INITIAL FIRE SAFETY INSPECTION REPORT

KDS Textile Mills Ltd.

RSC ID: 24481

Date: 15-09-2022

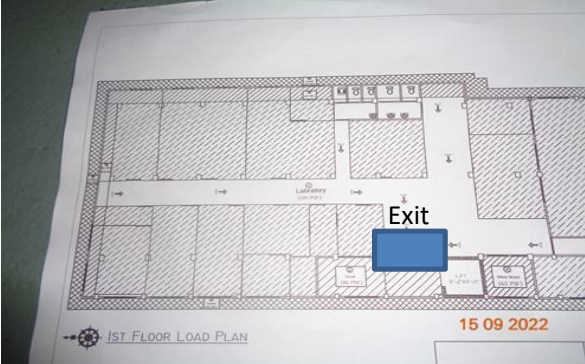
F-20	Fire Rated Construction	Rooms used for storage of combustible materials are not separated from the surrounding occupancy/areas. Location: Wastage store at 3rd floor and spare store at 2nd floor, Block B.	Provide dedicated storage rooms separated by minimum 1-hr fire-rated construction.	Within 3 months
